CITY OF West Linn

STAFF REPORT FOR THE PLANNING COMMISSION

FILE NUMBER: SUB-20-01
HEARING DATE: October 7, 2020
REQUEST: 6-lot Subdivision at 4096 Cornwall Street

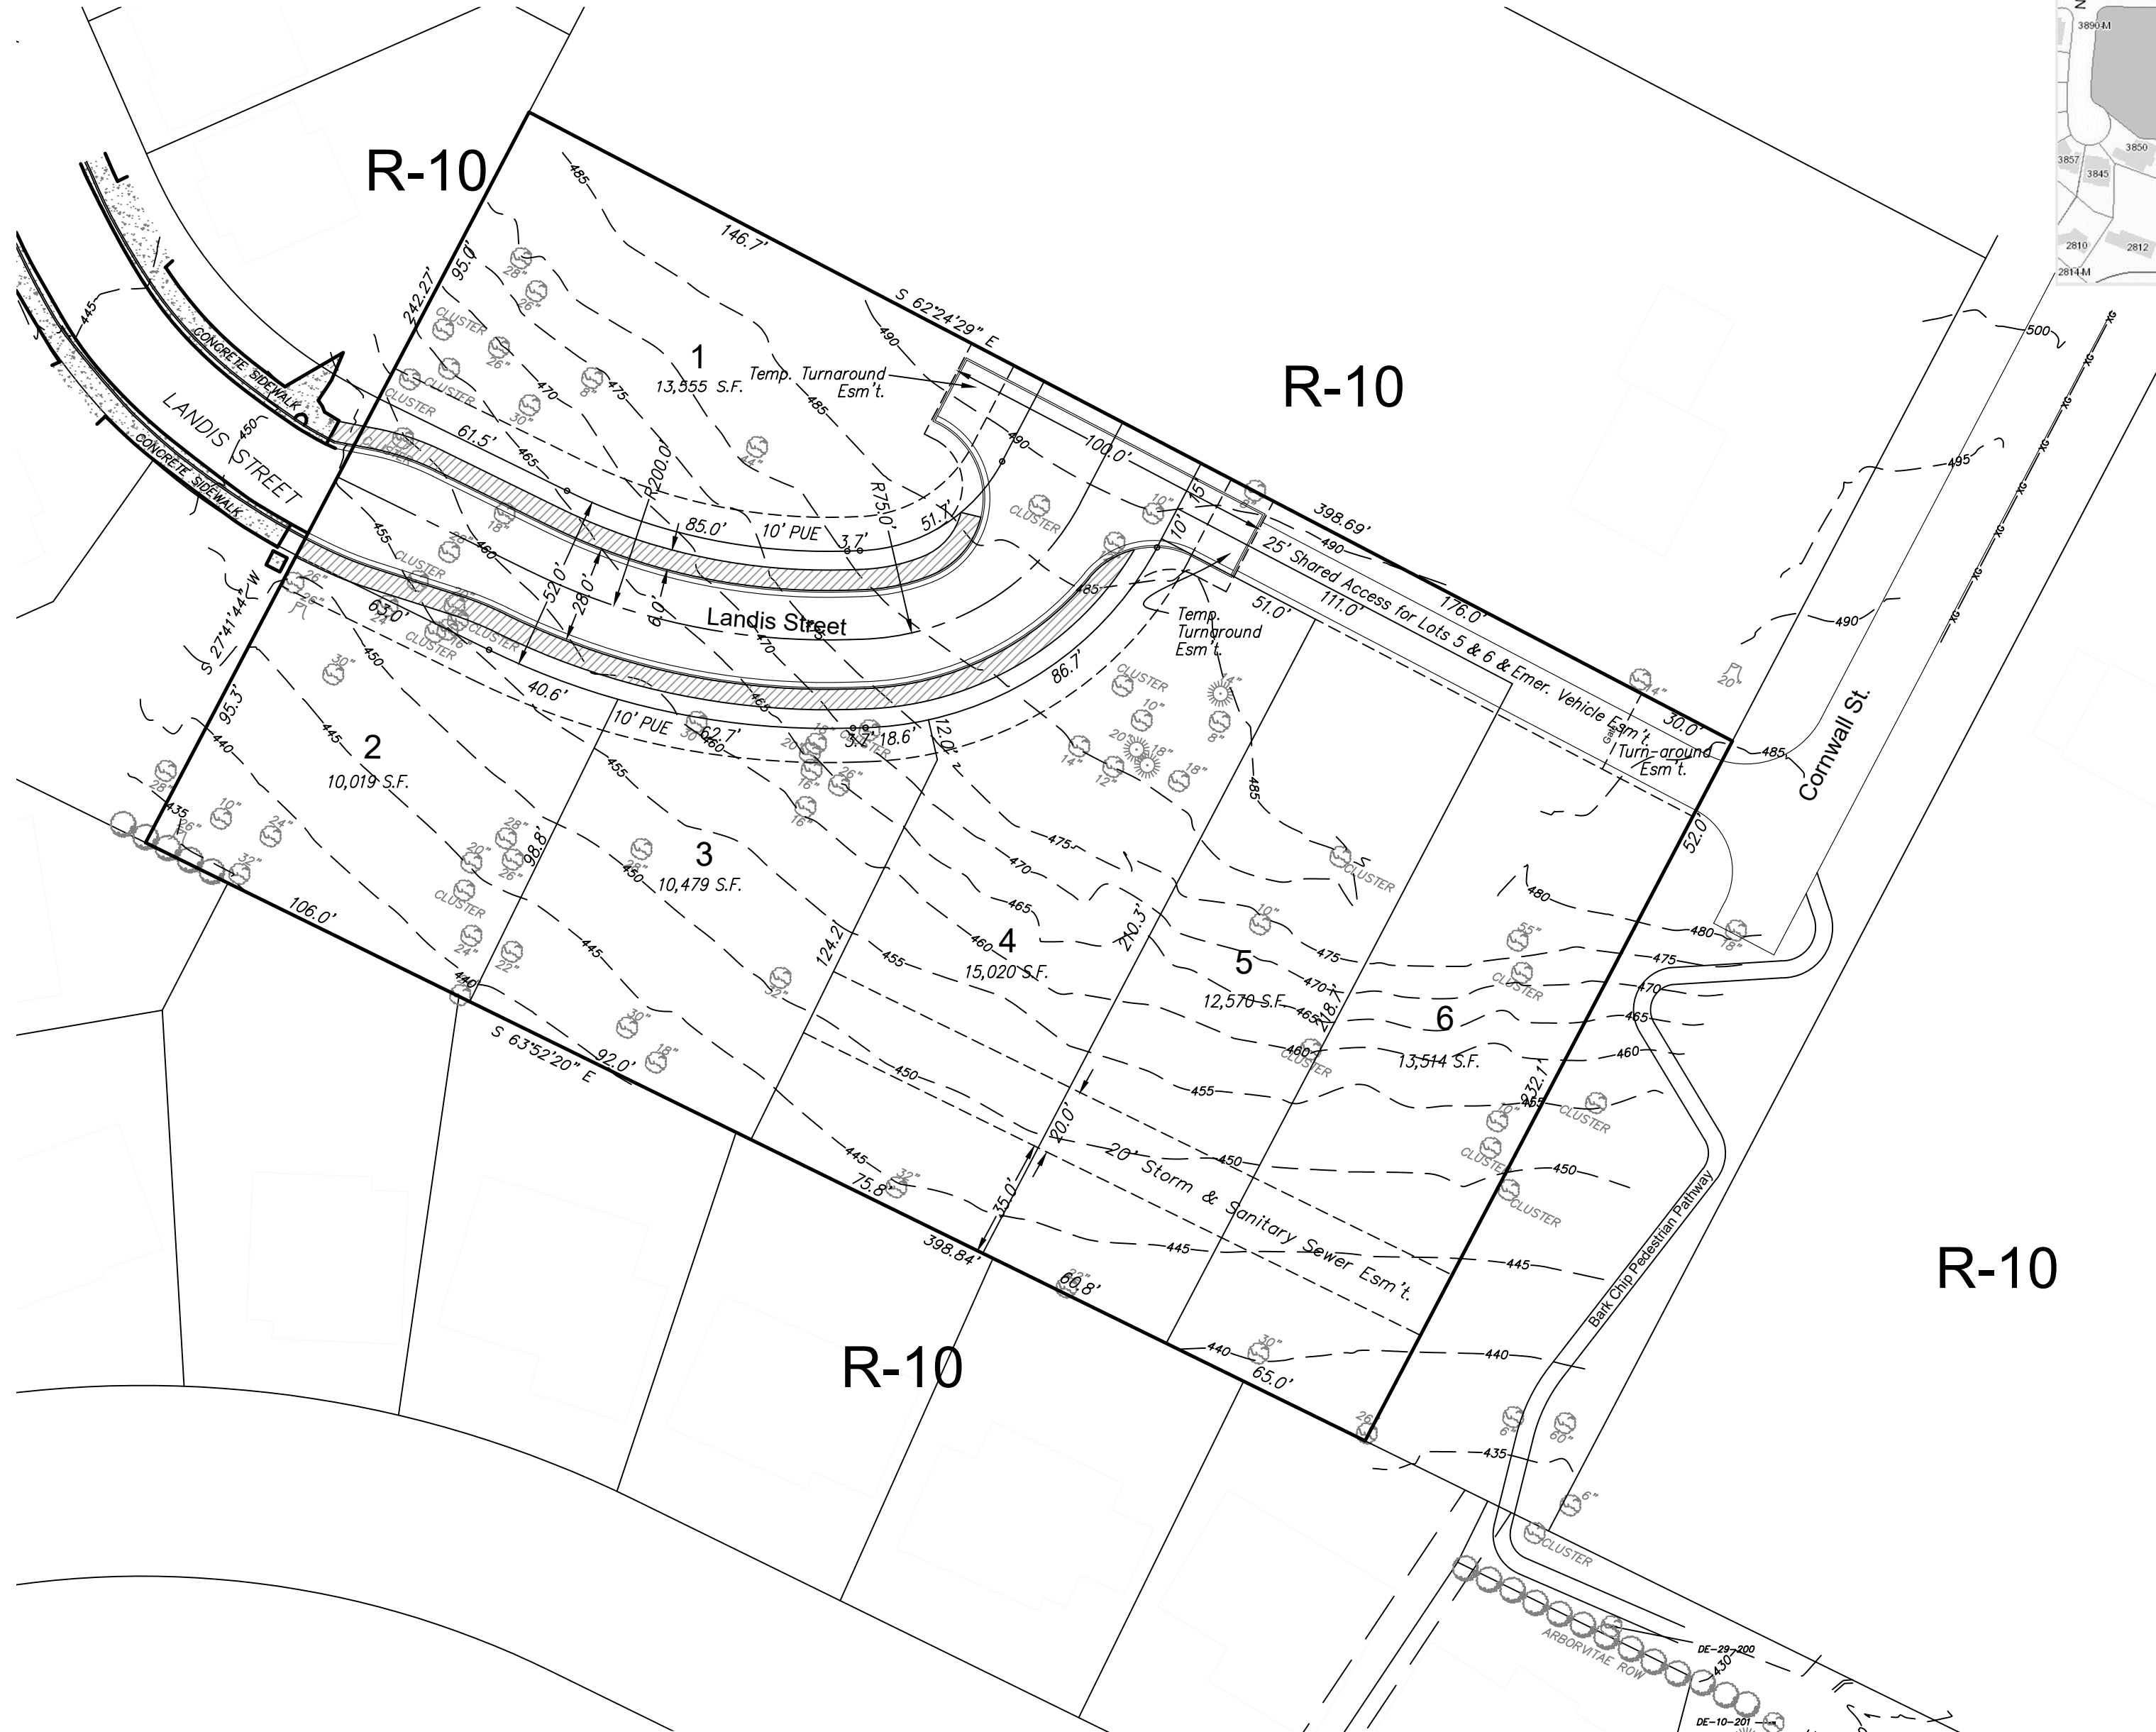
Staff Finding 4: See table in Staff Finding 3. In the Applicant’s proposed Tentative Plan, Lots 5 and 6 are flag lots. The total width for the shared access of Lots 5 and 6 is 25 feet. The shared private driveway connection does not meet required street connectivity standards of the Community Development Code nor the Transportation System Plan. Per Condition of Approval 4, the connection between Landis Street and Cornwall Street must be a public street, which eliminates the need for a reciprocal access easement. Also per Condition of Approval 4, Lots 5 and 6 shall take access directly onto the public street. All other lots meet this minimum lot frontage for a standard lot. Subject to the approval of proposed Conditions of Approval, the criteria are met.

Staff Finding 11: One access point to a public street is proposed for each lot. Proposed Lots 5 and 6 have a proposed shared driveway shown on the Applicant’s Tentative Plan. The applicant proposes recording a reciprocal access easement for the shared private driveway connection from Landis Street to Cornwall Street, which serves Lots 5 and 6. The shared private driveway connection does not meet required street connectivity standards of the

Staff Finding 17: The applicant has proposed a turnaround at the end of the Landis Street extension shown in the Tentative Plan. The Tentative Plan also shows a turnaround at the end of Cornwall Street that uses a gated emergency access easement in front of lot 6. Per Condition of Approval 4, the connection between Landis Street and Cornwall Street must be a public street and eliminates the need for a turnaround at the end of Cornwall Street. Also per Condition of Approval 4, Lots 5 and 6 shall take access directly onto the dedicated public street.

Staff Finding 24: The applicant proposes a 52 foot right-of-way for the extension of Landis Street. The applicant also proposes a 25 foot shared access for the flag 'poles' of Lots 5 and 6. The shared private driveway connection does not meet required street connectivity standards of the Community Development Code nor the Transportation System Plan. The TSP

Staff Finding 25: See Staff Finding 23. The Applicant's Tentative Plan shows a proposed 52' right-of-way. The Tentative Plan shows a 25 foot shared accessway for Lots 5 and 6. The shared access connects the extension of Landis Street to Cornwall Street for emergency access and the applicant has proposed to gate this accessway as it is not proposed to be public right-of-way. Per Condition of Approval 4, the connection between Landis Street and Cornwall Street must be a public street and not gated. Also per Condition of Approval 4, Lots 5 and 6 shall take access directly onto the dedicated public street. Subject to the approval of proposed conditions, this criteria is met.

4. **Shared Access.** The shared access shown on the Tentative Plan shall be widened to meet Public Works Standards for a future local street meeting the 28-foot local street standard. Lots 5 and 6 shall take access from the street. Per CDC 48.030(I) the proposed gate shall be removed from the Tentative Plan. A half-street plus travel lane for the local street shall be constructed to the City Engineering Standards and approved by the City Engineer prior to final plat approval. The applicant shall name the street and display the name on the surface of the plat prior to final plat approval. The applicant shall dedicate 32 feet of right-of-way for these improvements. (See Staff Findings: 4, 5, 8, 9, 11, 13, 14, 17, 18, 24, 25, 26, 29, 30-33, 36, 39, 47, 53, 55, 56, 61 & 63)

Community Development Code nor the Transportation System Plan. Per Condition of Approval 4, the connection between Landis Street and Cornwall Street must be a public street, which eliminates the need for a reciprocal access easement. Also per Condition of Approval 4, Lots 5 and 6 shall take access directly onto the dedicated public street. The criteria are met.

**TENTATIVE PLAN
PRELIMINARY STREET AND UTILITY PLAN**

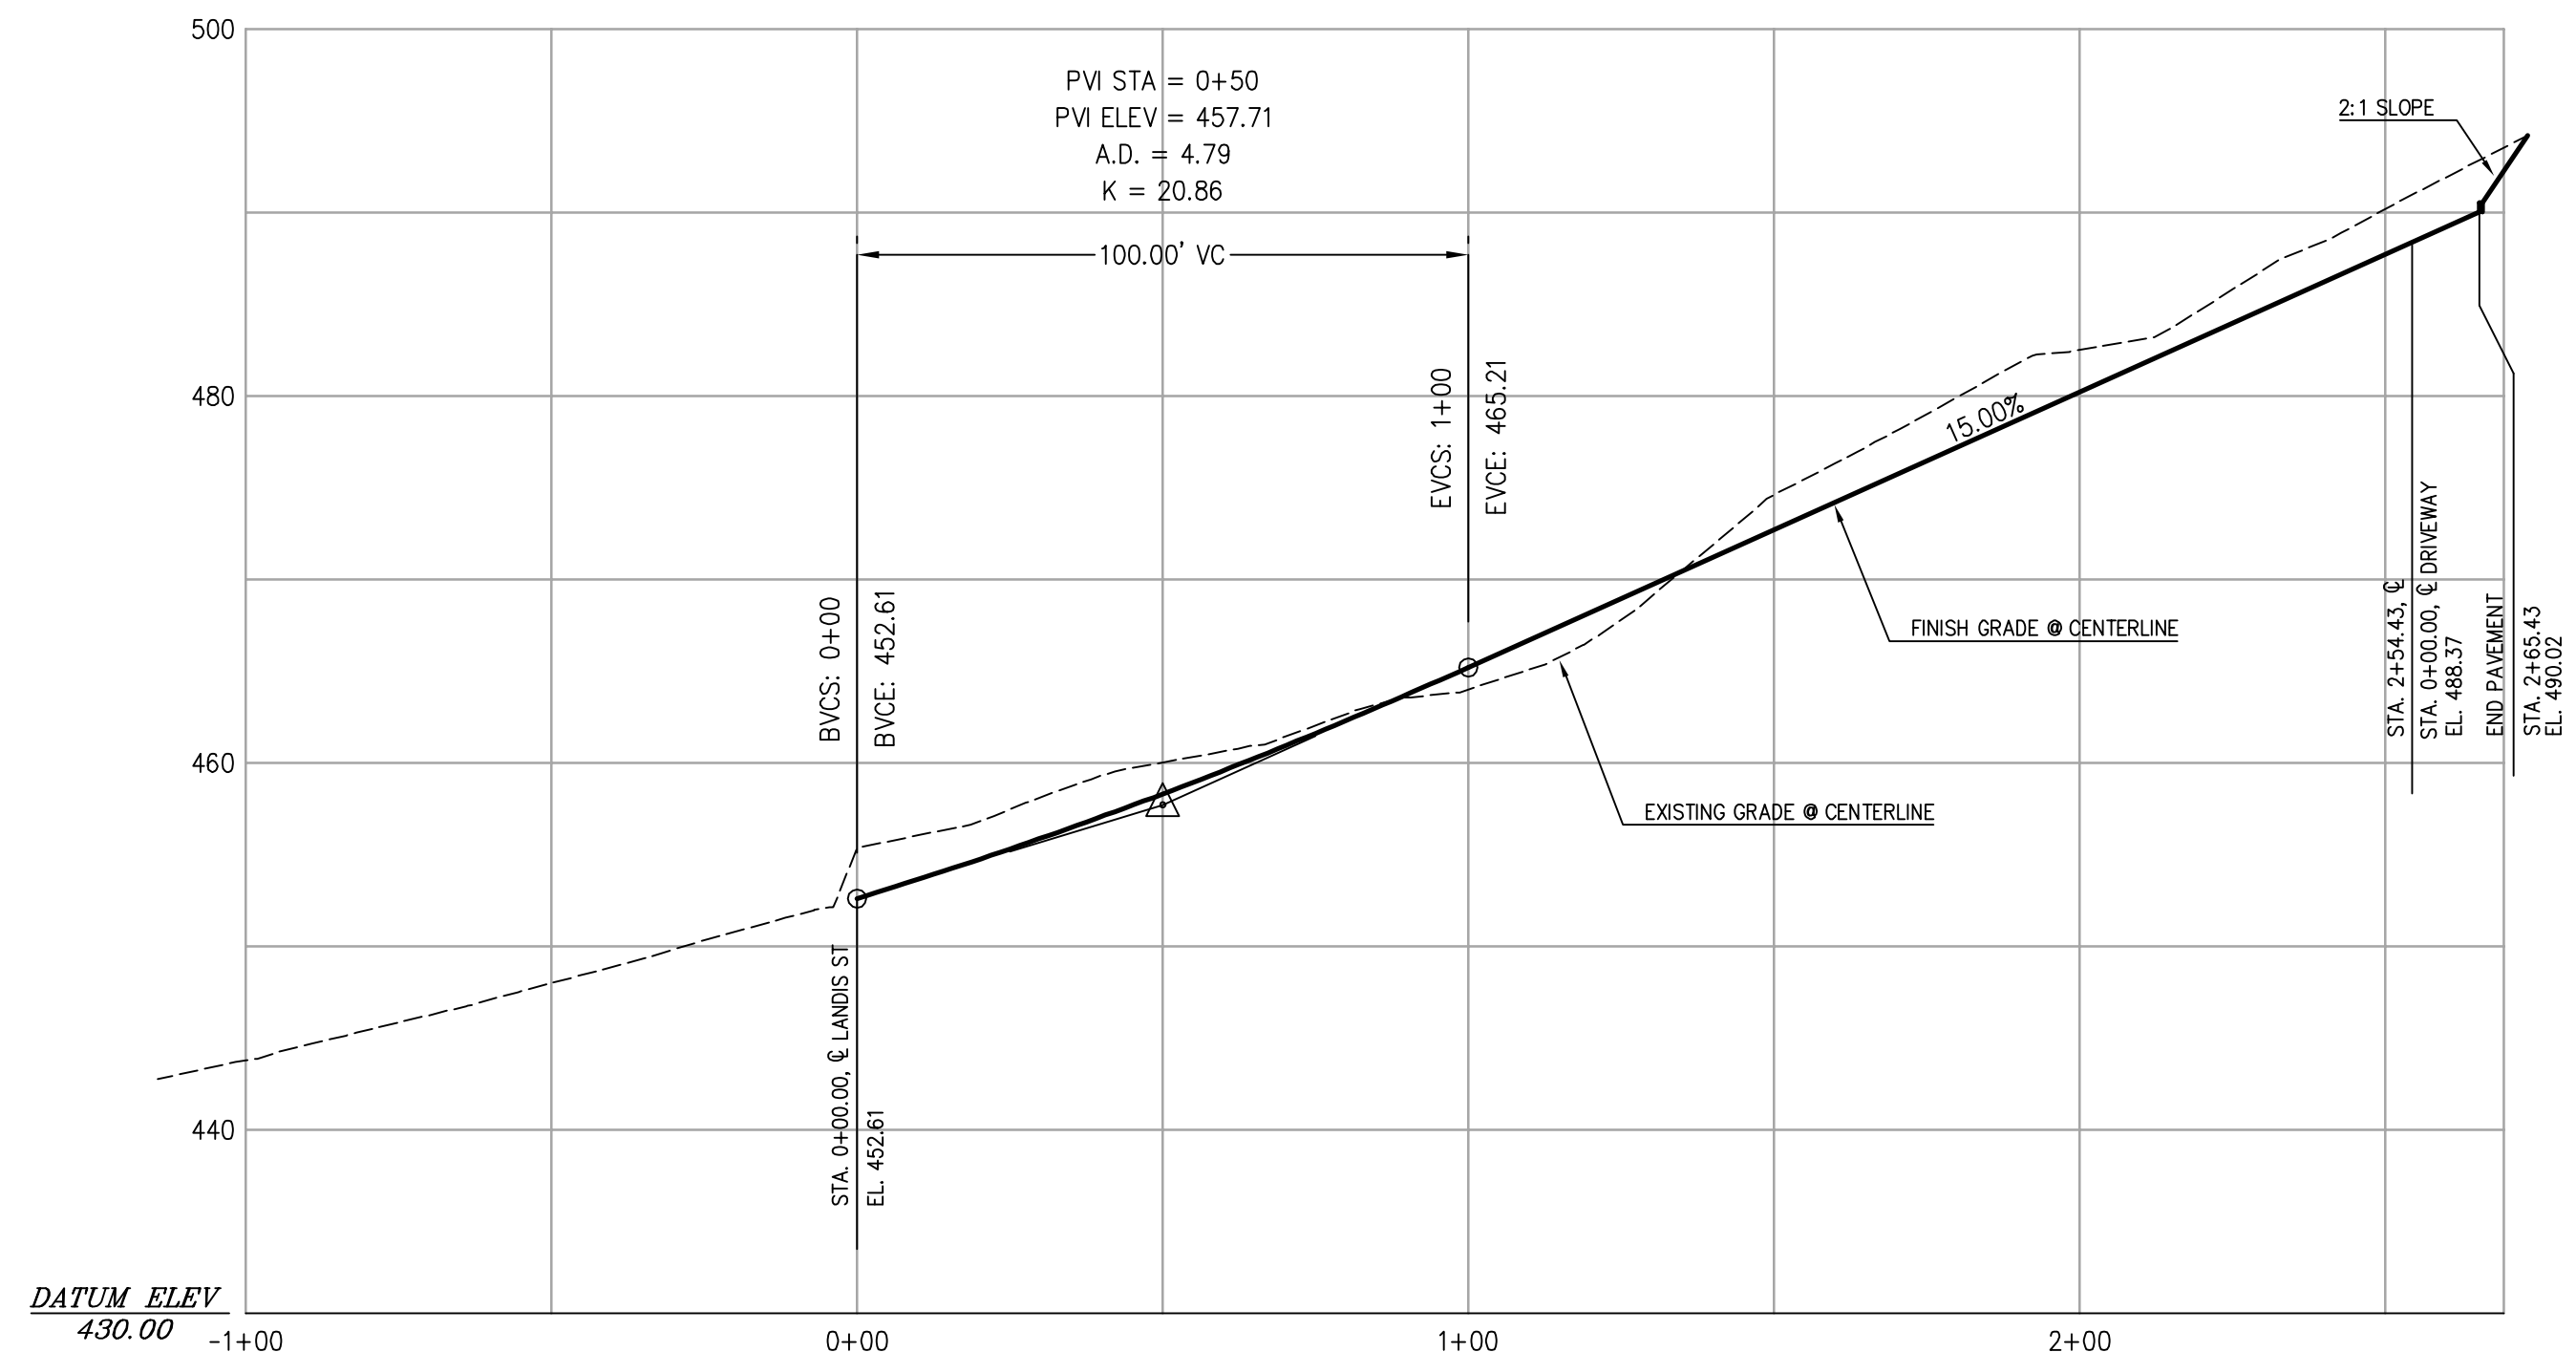
Staff Finding 43: The Sewer Master Plan has confirmed that there is sufficient sanitary system and sewage treatment facility capacity. In the Tentative Plan, the sewer line in the Landis Street right-of-way can only serve lot 1 due to topography. Sewer for lots 2-6 is proposed to be from a new sewer line to the south. The new sewer line will run through the rear yards of lots 2-6 and connect to an existing sewer main in the City tract at the end of Cornwall Street. The sewer shall be extended to the north property line in Landis Street and the unimproved Cornwall right-of-way for connection of future development. The applicant's submitted utility plan was prepared by a licensed Engineer and shown on sheet 1/3 titled Preliminary Street and Utility Plan. Subject to the Conditions of Approval, the criteria are met.

Staff Finding 59: The Sewer Master Plan has confirmed that there is sufficient sanitary system and sewage treatment facility capacity. In the Tentative Plan, the sewer line in the Landis Street right-of-way can only serve lot 1 due to topography. Sewer for lots 2-6 is proposed to be from a new sewer line to the south. The new sewer line will run through the rear yards of lots 2-6 and connect to an existing sewer main in the City tract at the end of Cornwall Street. The applicant's submitted utility plan was prepared by a licensed Engineer and shown on sheet 1/3 titled Preliminary Street and Utility Plan. The criteria are met.

3. **Public Utilities.** The applicant shall upgrade the water main in Cornwall Street to serve this proposed subdivision. The applicant shall extend the sanitary sewer mains to the north property lines in Landis Street and the unimproved Cornwall right-of-way to allow for future connection. All utilities shall be located within the public right-of-way or within recorded utility easements along property lines, as approved by the City Engineer. (See Staff Findings: 42 & 60)
